Planning Commission Final Agenda

Monday, February 10, 2025

SUBJECT: **Planning Commission Engineering Comments for ADM-2025-0001 John L Colbert Middle School Expansion**

SUBJECT: **Planning Commission Engineering Comments for ADM-2025-0002 KVS Sonic Group Subdivision**

LSD-2024-0032 APPROVED SITE PLAN

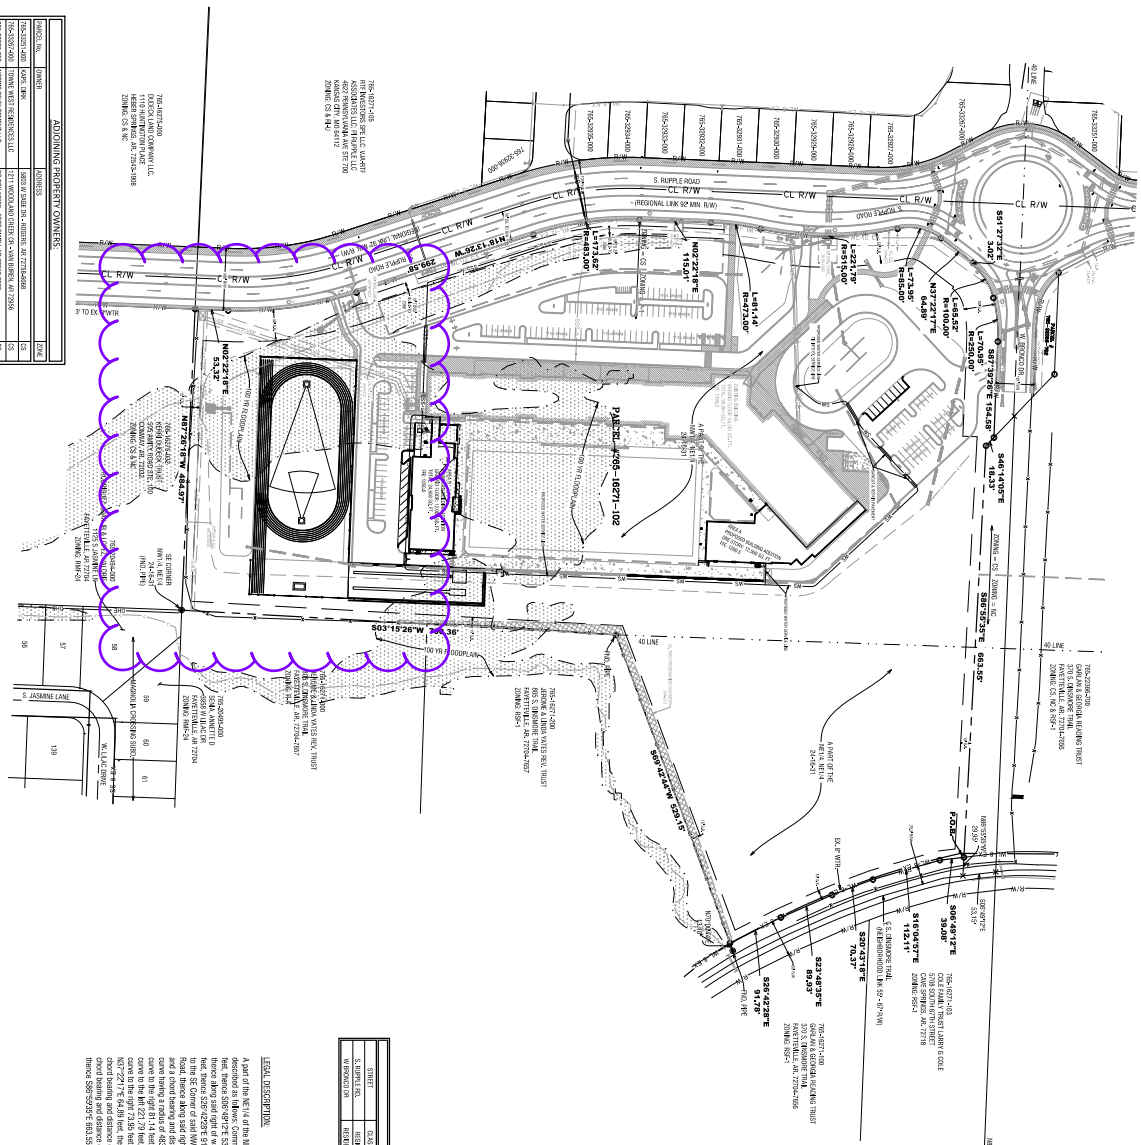
DISCUSSION:
Staff recommends approval of the applicant's request to amend their large-scale development as proposed. Pond 3 initially proposed to handle the added impervious are from the middle school expansion. However, with the revised plan to enlarge the track, the pond will be removed and replaced with an underground detention system./

Drainage: Previously, Pond 3 was proposed to be modified to accommodate the additional impervious area proposed with the middle school expansion. With the revised proposal to increase the size of the track, this pond is now shown to be removed and replaced with an ADS underground detention system with isolator rows to meet water quality requirements. Staff will review the revised drainage report with the grading permit to verify conformance with Minimum Standards 1-4 of the Drainage Criteria Manual.
